UNITED STATES PATENT AND TRADEMARK OFFICE

APPLICATION NO.	FILING DATE	FIRST NAMED INVENTOR	ATTORNEY DOCKET NO.	CONFIRMATION NO.
10/750,572	12/31/2003	Ali Keshavarzi	P18062	5687

Office Action Summary

DETAILED OFFICE ACTION

FIG. 13

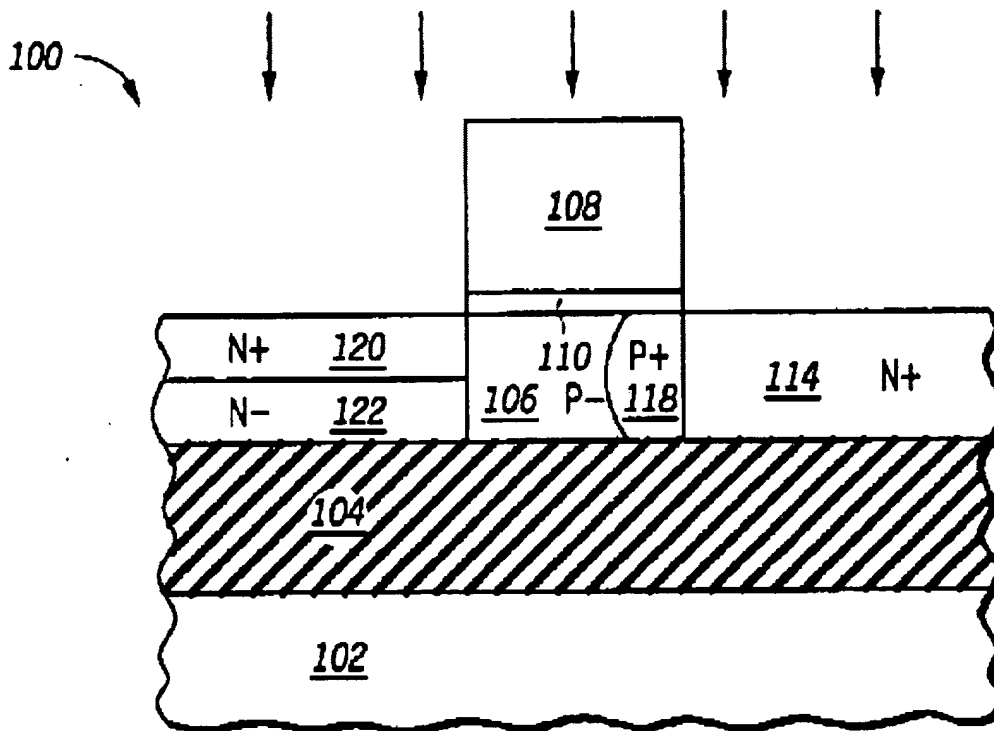
Burnett discloses (in fig 13, column 1 lines 59-60) a memory cell comprising: a body region (region 106 in fig 13) doped with charge carriers of a first type; a source region (source region 120,122) disposed in the body region, the source region doped with charge carriers of a second type; and a drain region disposed in the body region, the drain region (drain region doped with charge carriers of the second type, wherein the body region and the source region form a first junction, wherein the body region and the drain region form a second junction, and wherein a conductivity of the first junction from the body region to the source region in a case that the first junction is unbiased is substantially less than a conductivity of the second junction from the body region to the drain region in a case that the second junction is unbiased. Noted even though Burnett does not mentioned the limitation “ wherein the body region and the source region form a first junction, wherein the body region and the drain region form a second junction, and wherein a conductivity of the first junction from the body region to the source region in a case that the first junction is unbiased is substantially less than a conductivity of the second junction from the body region to the drain region in a case that the second junction is unbiased. “; the structure discloses by Burnett in fig 13 fully anticipate this limitation of claim 1 due to the doping profile of the source

(N+ and N- doped) compared with the drain (N+ doped) therefore the conductivity of the drain is more than the conductivity of the source when unbiased.

Burnett discloses (in fig. 13, region 118) a halo implant region to form at least a portion of the second junction and the Halo implant is more heavily doped (P + doped) than the body region 106 (P- doped)
